# UNITED STATES PATENT AND TRADEMARK OFFICE

APPLICATION NO.	FILING DATE	FIRST NAMED INVENTOR	ATTORNEY DOCKET NO.	CONFIRMATION NO.
10/821,860	04/12/2004	Federico Cabrele	713-1121	1818

**Office Action Summary**

### DETAILED ACTION

FIG. 5

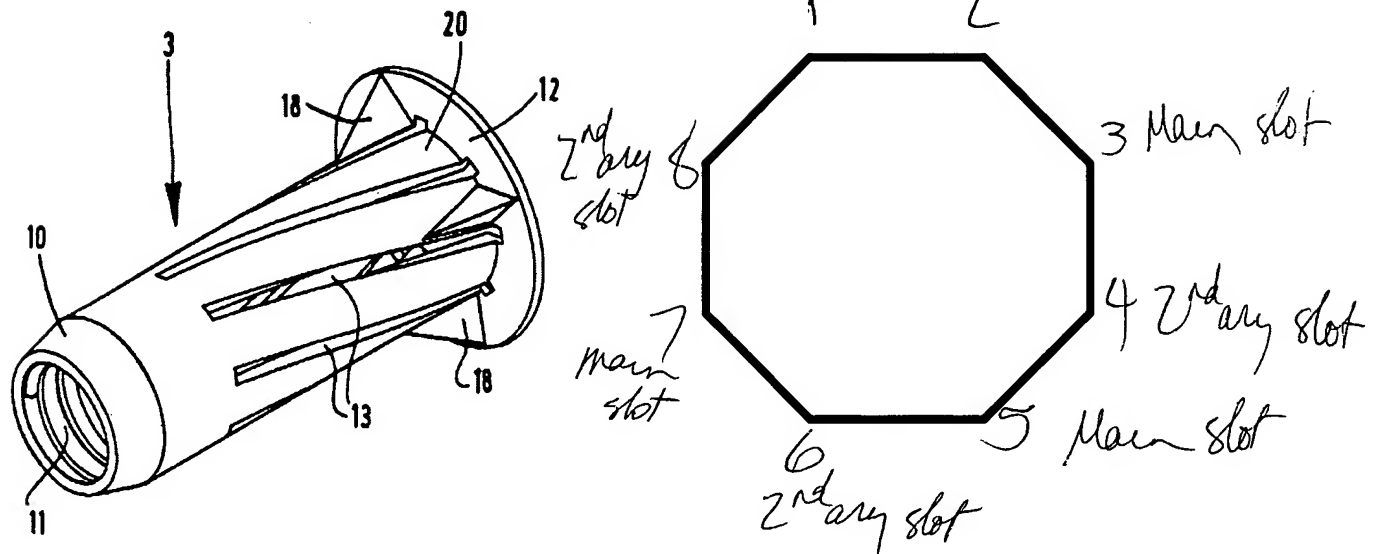
Re claim 3: Pairs of main longitudinal slots define main longitudinal anchoring tongues (strip between two "13's". It appears there are 8 equally-spaced slots "13" - examiner has labeled <sup>an</sup> ~~an~~ octagon below which are considered main and which are considered secondary.

Re claims 6-7: Fig 5 and col 3 lines 66-69 teach evenly angularly spaced slots.

Re claims 8-9: referring to the numbering by examiner of the octagonal shape, representing the collar with 8 slots of Vernet, slots 1&6, 2&5, 3&8, and 4 & 7 face and are coplanar, and assuming <sup>1, 3, 5 and 7</sup> 1 and 7 are "the adjacent" main slots,

Re claims 10-12: a head with a collar at a first end, said collar with annular flange (12) coaxial with longitudinal axis as shown in Fig 5 above. Projecting appendices (18) are shown as equally spaced and integral with collar and parallel to longitudinal axis. There is a head (10) at opposite end.
